# Request for Proposal

Date: 8/9/2023  
Project Name: UA 310 ARKV Renovation  
Project No.: 21085  
Owner: University of Arkansas - Fayetteville

**RFP NO: 02**

PROPOSAL REQUEST NUMBER: TWO (2)

M5.01

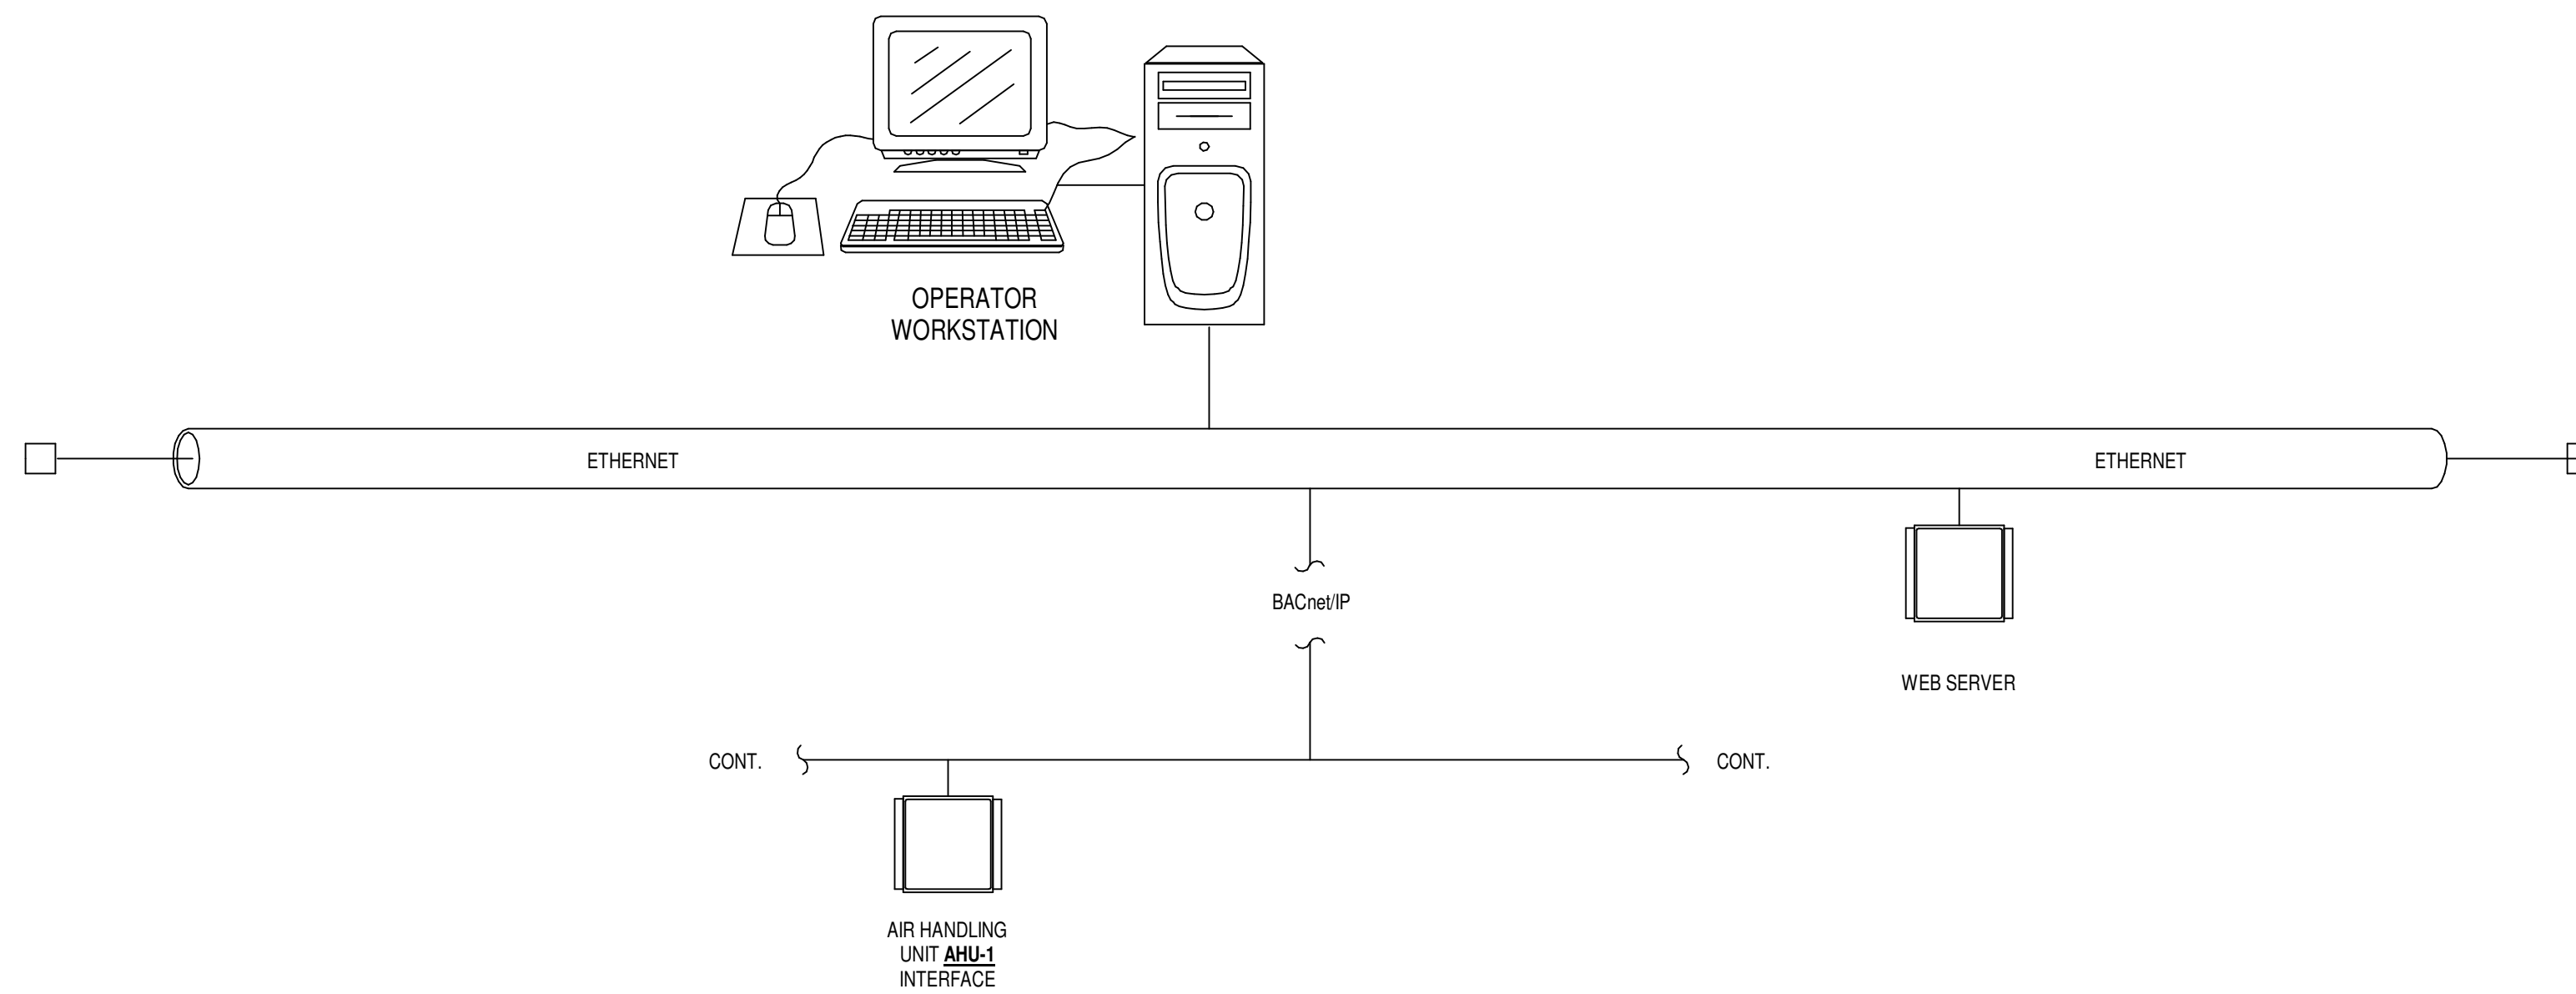
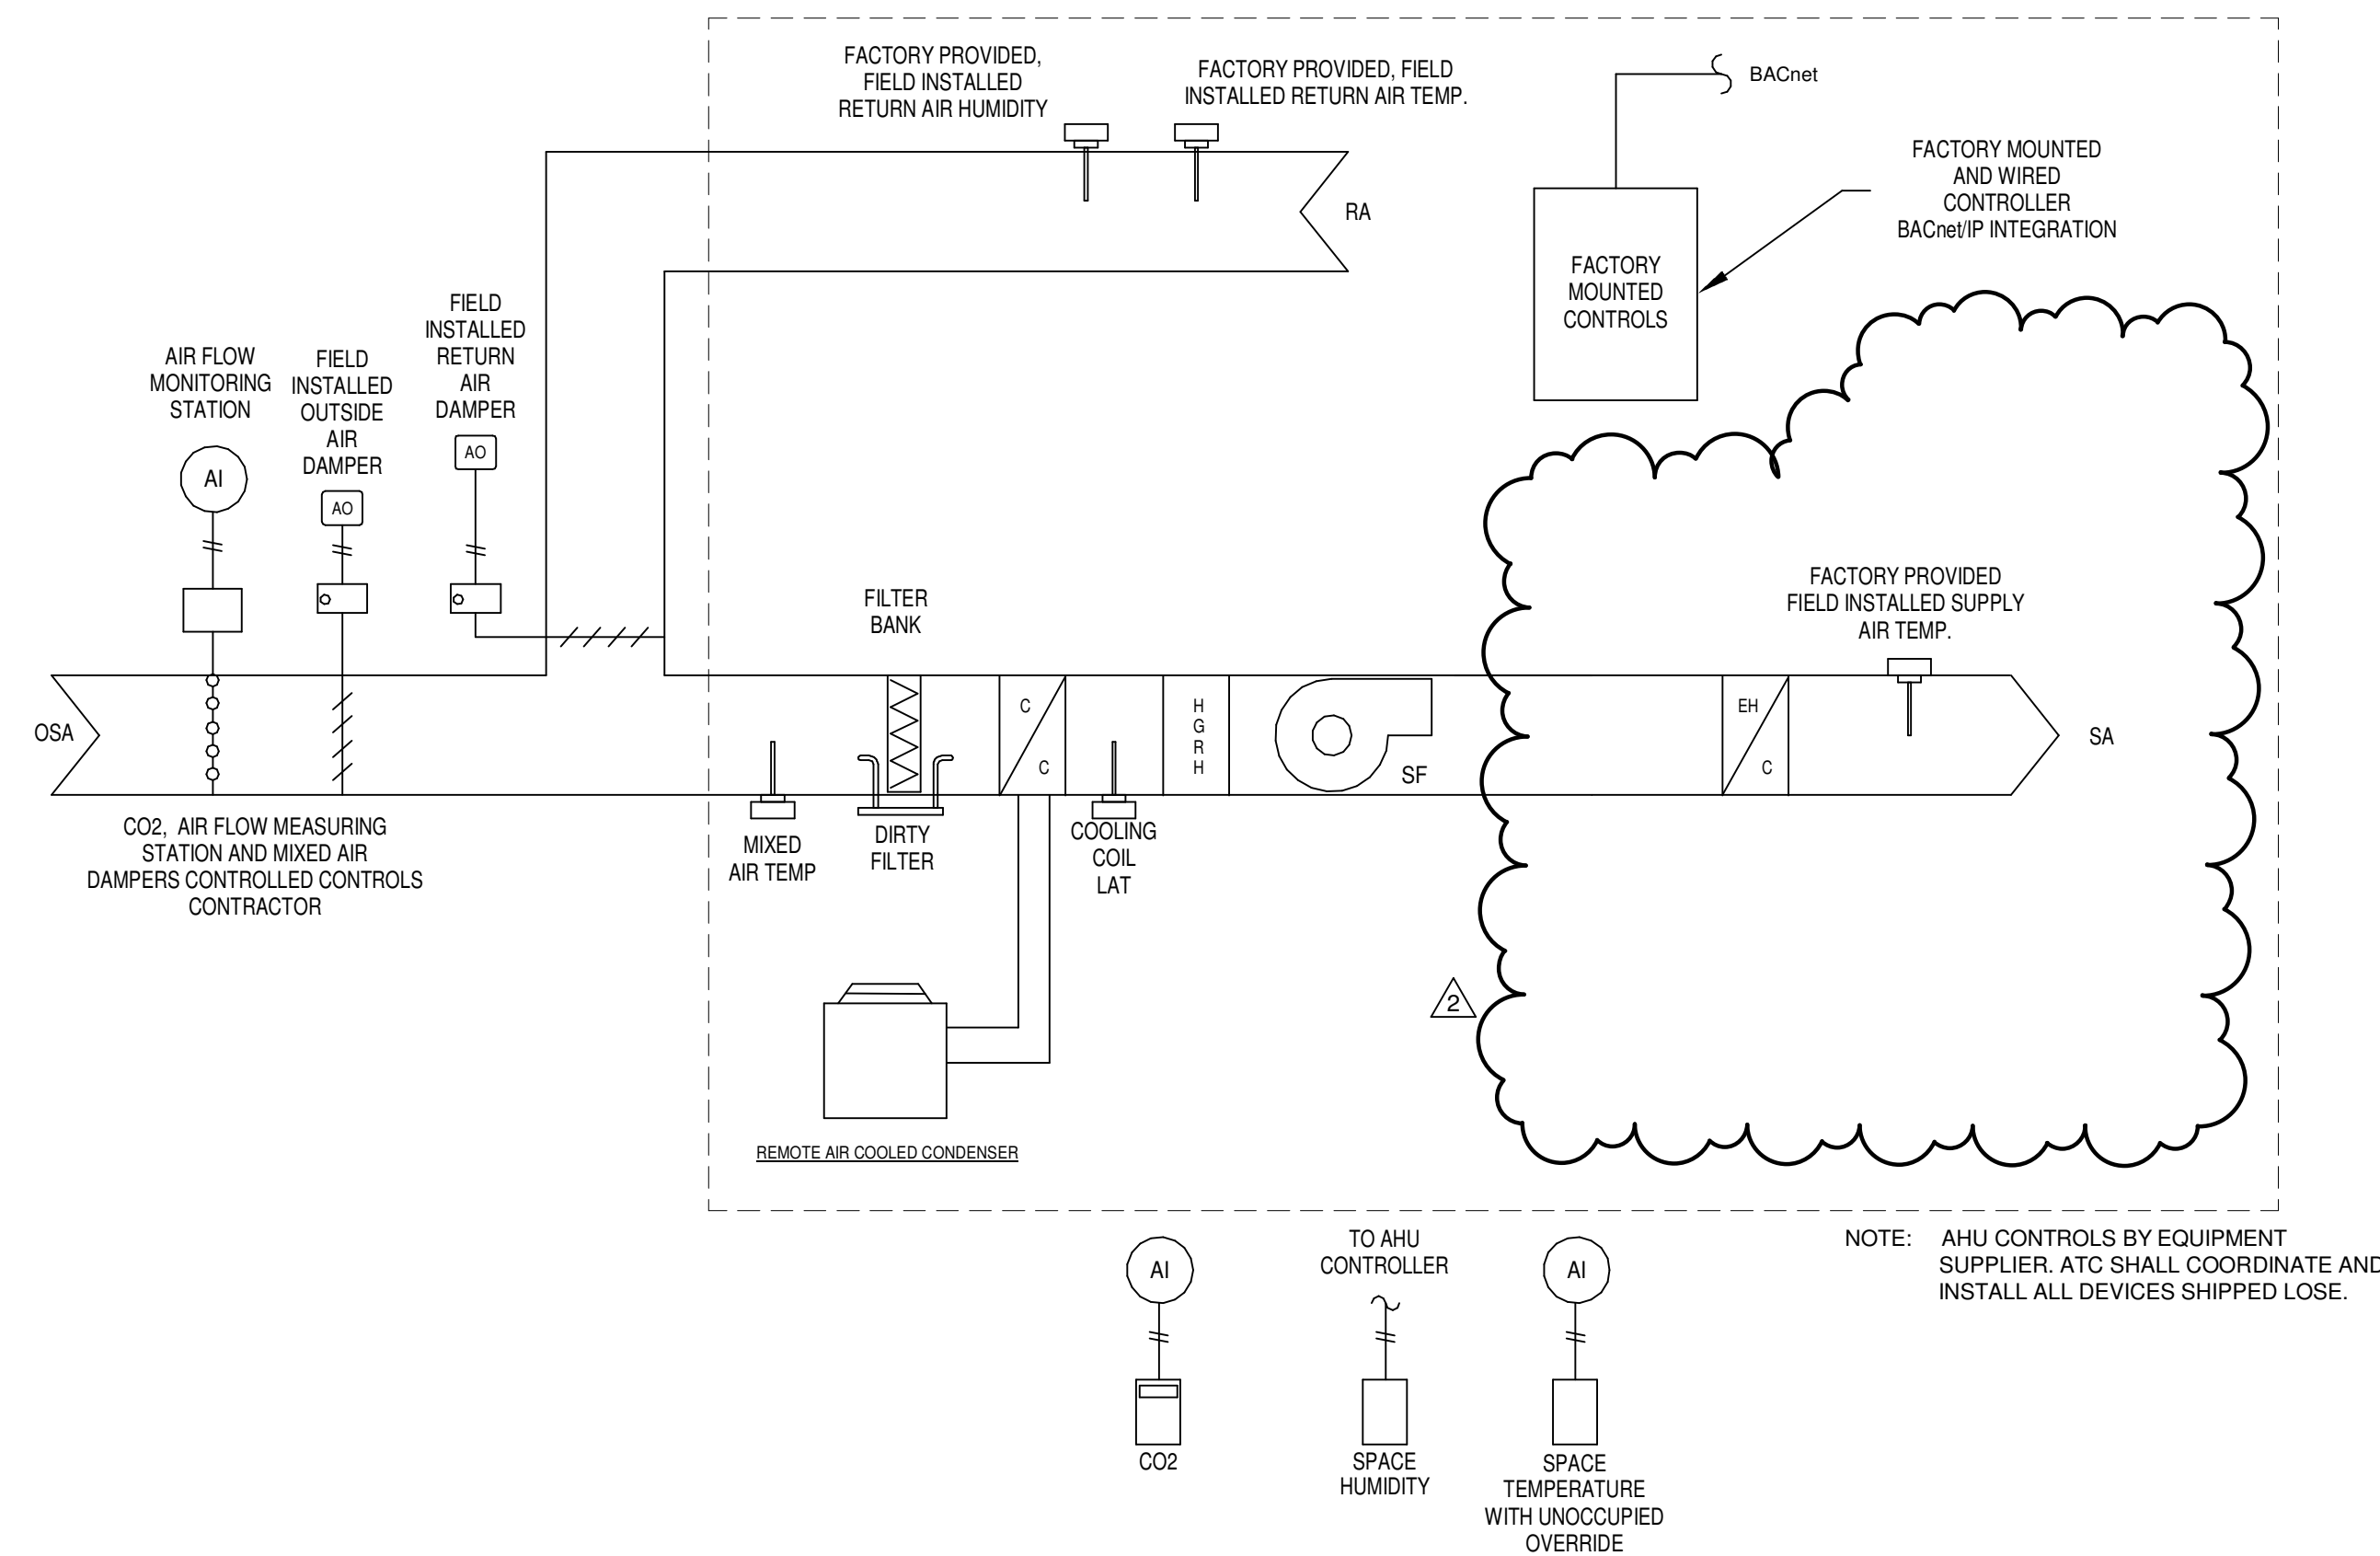
- A1.** REFER TO SHEET M1.01 AND M2.01 FOR DUCTWORK ROUTING REVISIONS. ADDITIONALLY, EDH-1 HAS BE REVISED AND RELOCATED, EDH-2 HAS BEEN DELETED, AND CU-1 HAS BEEN RELOCATED.
- A2.** REFER TO SHEET M4.01 REVISIONS TO THE DUCT HEATER SCHEDULE.
- A3.** REFER TO SHEET M5.01 REVISIONS TO THE DUCT HEATER CONTROLS DIAGRAM AND SEQUENCE OF OPERATIONS.
- A4.** REFER TO SHEET E1.03 FOR REVISIONS TO THE DUCT HEATER EDH-1 AND THE DELETION OF EDH-2. CU-1 WAS ALSO RELOCATED.
- A5.** REFER TO SHEET E2.01 FOR REVISIONS TO PANEL "A". A NEW 125A/3P BREAKER SHALL BE PROVIDED FOR EDH-1. THE ORIGINAL BREAKERS FOR EDH-1 AND EDH-2 SHALL BE LABELED AS SPARE.
